TECHNICAL SERVICE BULLETIN

Technical Service Bulletin: 51-1576

JACK INSPECTION, REMOVAL AND REPLACEMENT (IF NEEDED) FOR 8K JACKS ON MOTORIZED UNITS

TSB Number:	85-001-2022		
Product:	8K Leveling Jacks		
Date:	November 18, 2022	Labor Rate:	0.3 Hour Inspection per Unit
			1.0 Hour Replacement per Jack

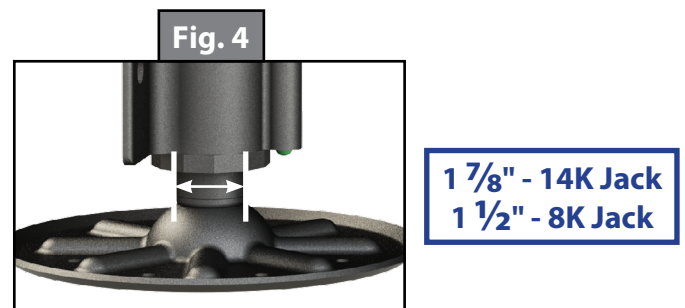
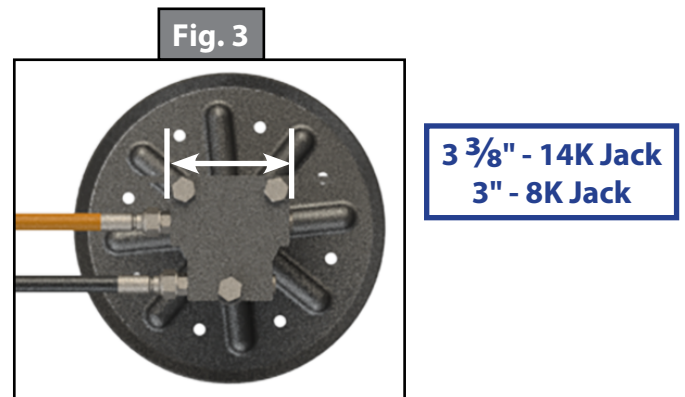
1. Inspect the unit's 8K jacks to determine if they are Gen I or Gen II jacks. Gen I jacks have ports on the side (Fig. 1) and Gen II jacks have ports on the top (Fig. 2).

NOTE: If it is determined that the unit has Gen II jacks, then no replacement per this TSB is required. If unit has Gen I jacks, proceed with inspection.

Fig. 5

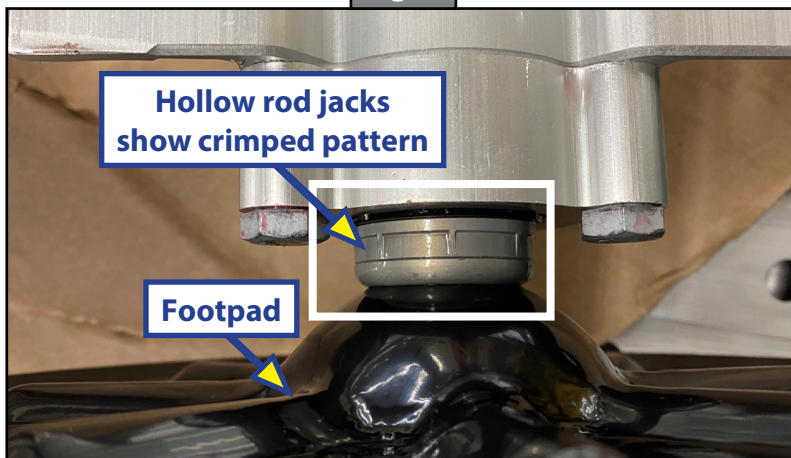
3. If the unit has 8K Gen I jacks, the ONLY Gen I jacks involved in this TSB document have a crimped pattern which indicates a hollow rod (Fig. 5), visible even when the jack is retracted. Solid rod jacks do not have the crimped pattern (Fig. 6), showing a solid smooth edge around the machined end.

Fig. 7

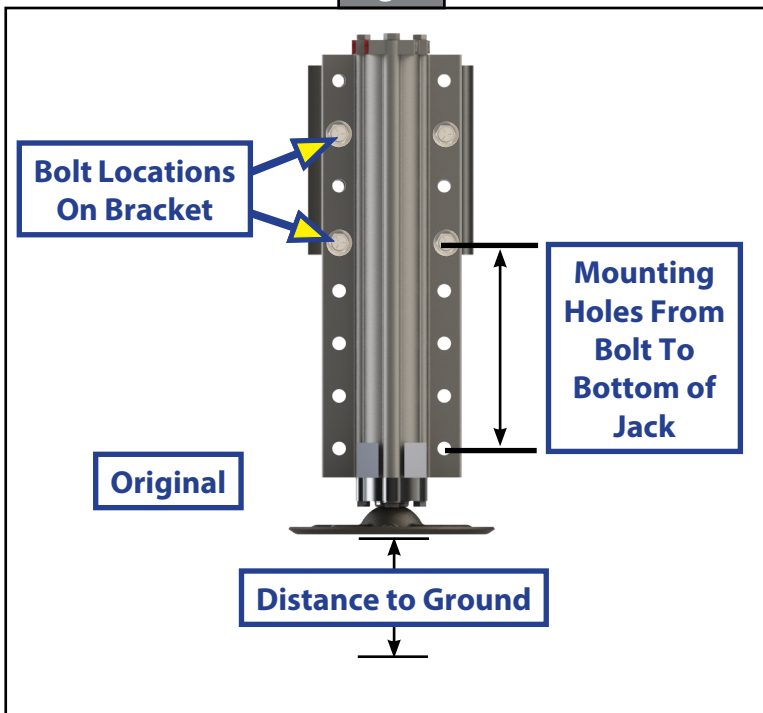
1. Before removing the original jack, note the location of the mounting holes on the jack and the mounting bracket (Fig. 7 or Fig. 8).

2. Measure the distance from the ground to the footpad of the retracted jack (Fig. 5 or Fig. 6).
3. When reinstalling jacks, match the number of mounting holes from the first bolt to the bottom of the jack (Fig. 7 or Fig. 8).
4. When reinstalling jacks, be sure to install bolts in the same location based on the number of mounting holes to the bottom of jack.
5. Once installation of the Gen II jack has been completed, measure the distance from the footpad to the ground to verify installation is correct.

Fig. 8

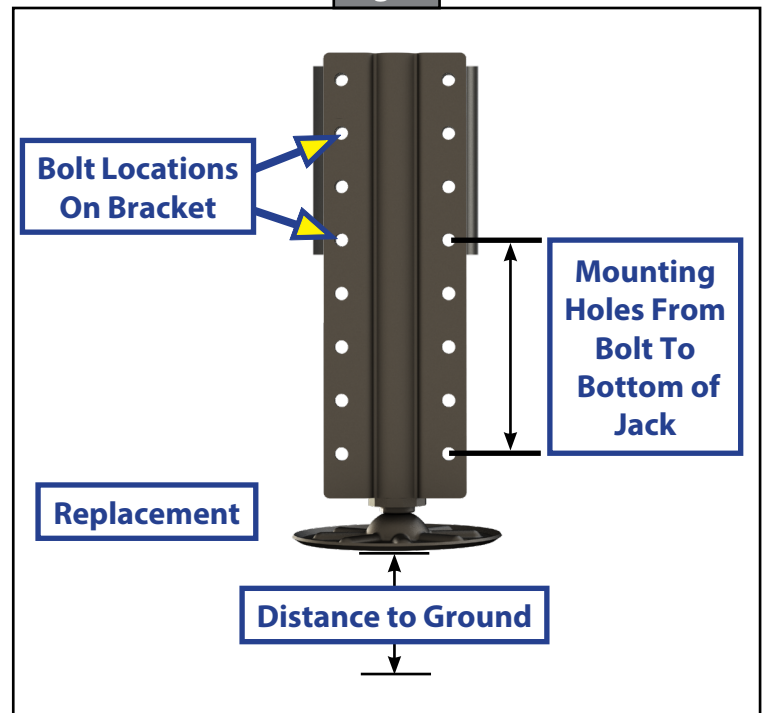
1. Remove hoses from the 8K jacks on the unit.
2. Follow procedures outlined in the Replacement Jack Location section, and then unbolt and remove existing leveling jacks (Fig. 7).
3. Match the number of mounting holes from the first bolt to the bottom of the jack and then bolt the new Gen II jacks (Fig. 8) to the mounting brackets.
 - A. Upper and lowermost bolts are vertically spaced with a minimum of two-hole patterns spaced 4.5" apart (Fig. 9) and tightened. Torque to 90 ft-lbs for a lubricated bolt or torque to 120 ft-lbs for dry bolt. A spacing of three-hole patterns (6.75") is recommended where possible.
4. Measure the distance from the footpad to the ground to verify installation is correct.
5. Connect the hoses to the new 8K Gen II jacks.

Fig. 10

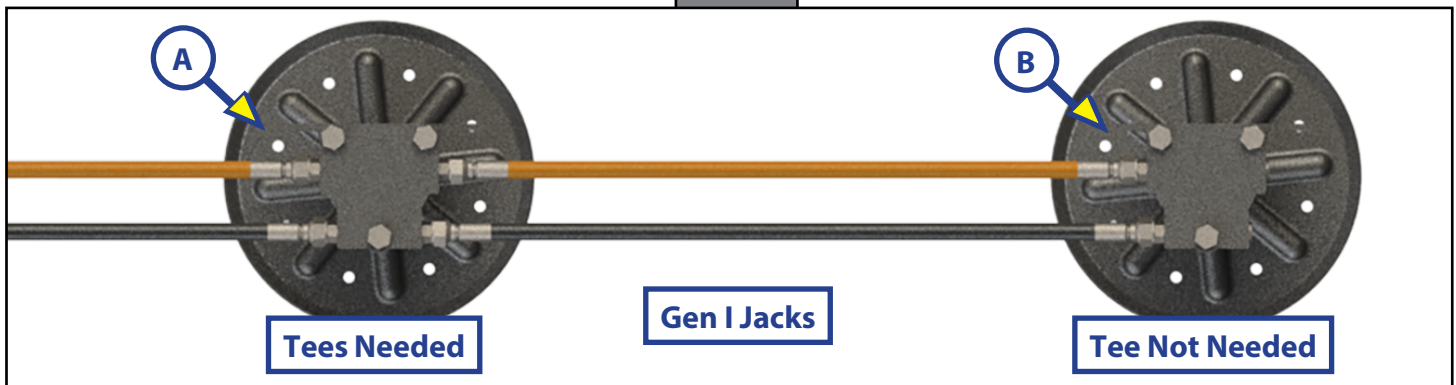
- A. If the Gen I jack has two orange extend hoses and two black retract hoses (Fig. 10A), an O-ring face tee fitting (Fig.11) must be used to connect the hoses to the single extend and retract hoses on the Gen II jack (Fig. 11).
- B. If the Gen I jack has only one orange extend hose and one black retract hose (Fig. 10B), a 90-degree O-ring face elbow fitting (Fig. 11) will be needed to connect the single black and orange hoses to the Gen II jack (Fig. 11).
